Mr. Jim Bradley
Town of Fairfield
Penfield Building Committee
June 19, 2014

This will confirm and expand on the comments I made at your Committee's 6/12/14 meeting regarding improvements to the existing timber bulkhead.

PENFIELD PAVILION
FAIRFIELD, CT

PROPOSED DUNE

Project Number	2013-18	Date	01-15-2013
Drawn by	JAP	Checked by	AK (initial)
Checked by	JAP	Scale	AS SHOWN
Job No.	JOR	Sheet No.	0
DATE	01-15-2013	PROJECT	S-01

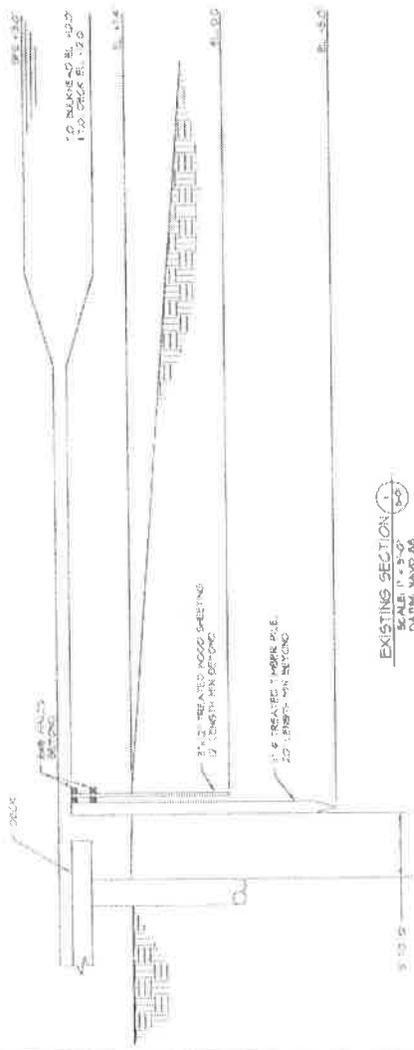
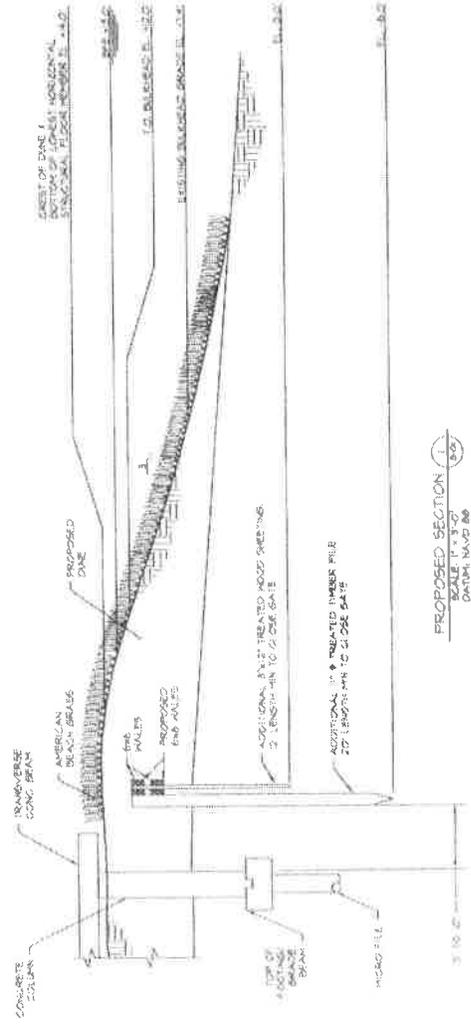
1. The face of the dune/bulkhead should slope upward to the crest and be planted with beach grass as recommended on RACE's drawing S-01 which is a part of the original, JM Albane pavilion failure analysis – see attachment #1.
2. For some additional background on the 'Grand Plan' see the attached section from the NFWF Grant Request to improve the dune/dike system at the easternmost town shorefront and Exhibit B.
3. Attachment #2 is a slide from the presentation made in April, 2014 to the Pine Creek Residents Association which shows the recommendation to raise the Sound facing portion of that existing dike to 17 ft. This is the common *formula* of **BFE + 2 ft.**
